01-010/14 - MULTI-MODEL (WITH SKYACTIV 2.0L/2.5L) - MIL ON WITH DTC P0191:00 OR P0192:00

Service Bulletin

CHECK ENGINE LIGHT ON WITH DTC P0191:00 OR P0192:00

Last Issued: 04/29/2014

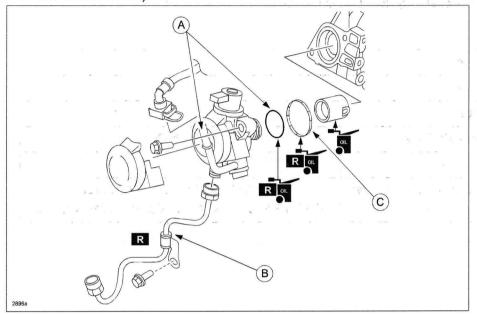
Some vehicles may experience the check engine light on with DTC P0191:00 or DTC P0192:00 stored in memory.

This is caused by the high pressure fuel pump not generating the target fuel pressure (due to a manufacturing error of the inner parts). To correct the problem, production control has been improved.

- 1. Verify customer concern.
- 2. Replace the high pressure fuel pump with a modified one according to the Workshop Manual.
- 3. Replace the high pressure fuel pump (A: fuel pump; B: fuel pipe; C: rubber seal) with a modified one according to the instructions on MS3 online or the Workshop Manual (section 01-14 HIGH PRESSURE FUEL PUMP REMOVAL/INSTALLATION).
